Letter of Transmittal

12720 LIVERNOIS AVE.
(RUSSELL WOODS VENUE)

**REQUEST ENCROACHMENTS INTO
THE EASTERLY PART OF LIVERNOIS AVE.
AT 12720 LIVERNOIS AVE.**

PROPOSED "RENTAL HALL"

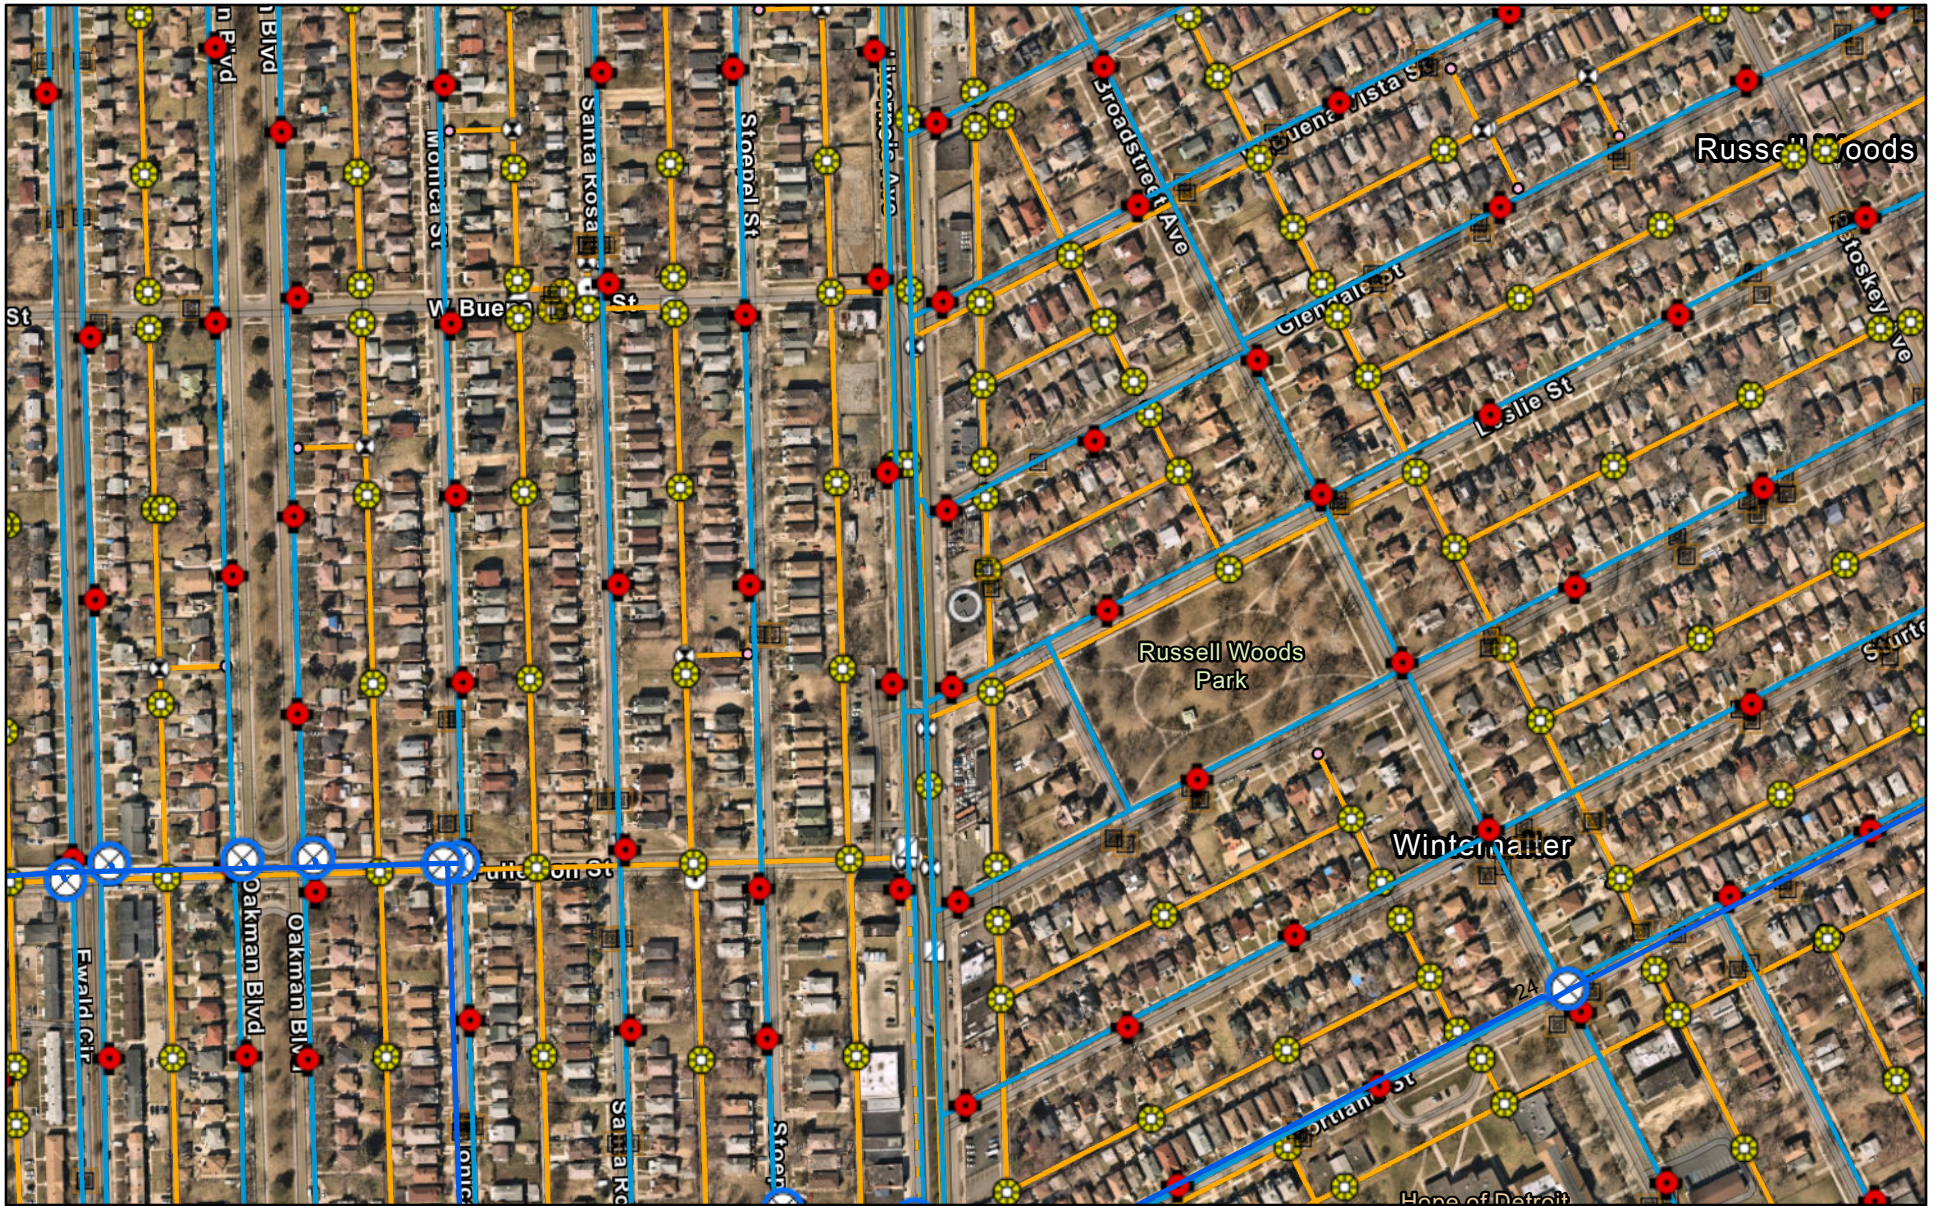
- Our records indicate that there are water mains and sewers which are located in the vicinity of the proposed project limits, the locations must be field verified to maintain our required clearances

- It is DWSD's requirement that any proposed utility crossing DWSD water mains or sewers perpendicularly must maintain a minimum of 1.5 feet vertical clearance below DWSD assets. Also, any proposed utility running adjacent to DWSD water mains and sewers must maintain a minimum of 3.5 feet horizontal clearance from any conduit and/or manhole outside wall. No utility is allowed to run along the top of the water main or sewer.

- There are possibilities of several water and sewer service lines crossing in the vicinity of proposed work, field verify their location and depth to maintain our required clearance.
